Product Change Notification / ALAN-09TNMZ646

CCB 4981 Final Notice: Qualification of A194 as an additional Lead-frame for various device families available in 44L PLCC (16.6x16.6x4.4mm) package.

CCB 4981
Pre and Post Change Summary
PCN# ALAN-09TNMZ646

Pre and Post Change Summary

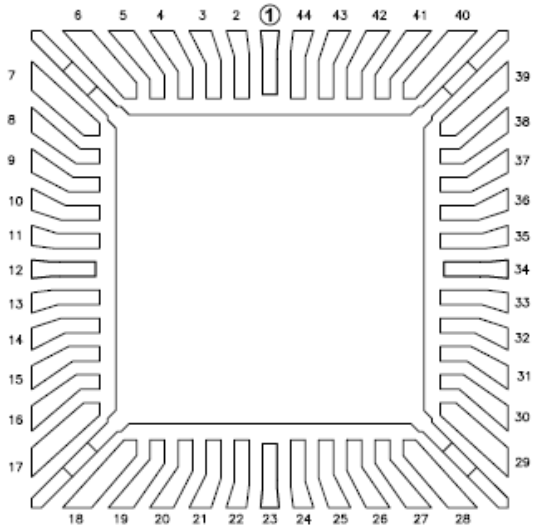
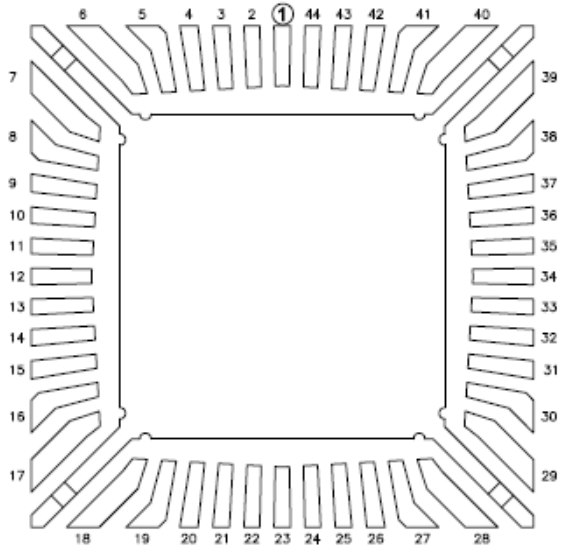
LF PART#: 10104409

Material	C151
DAP Surface Prep	Ag Spot plated
Treatment	None
Process	Stamped
Lead-Lock	No

LF PART#: 10104414

Material	A194
DAP Surface Prep	Bare Cu
Treatment	BOT
Process	Etched
Lead-Lock	No
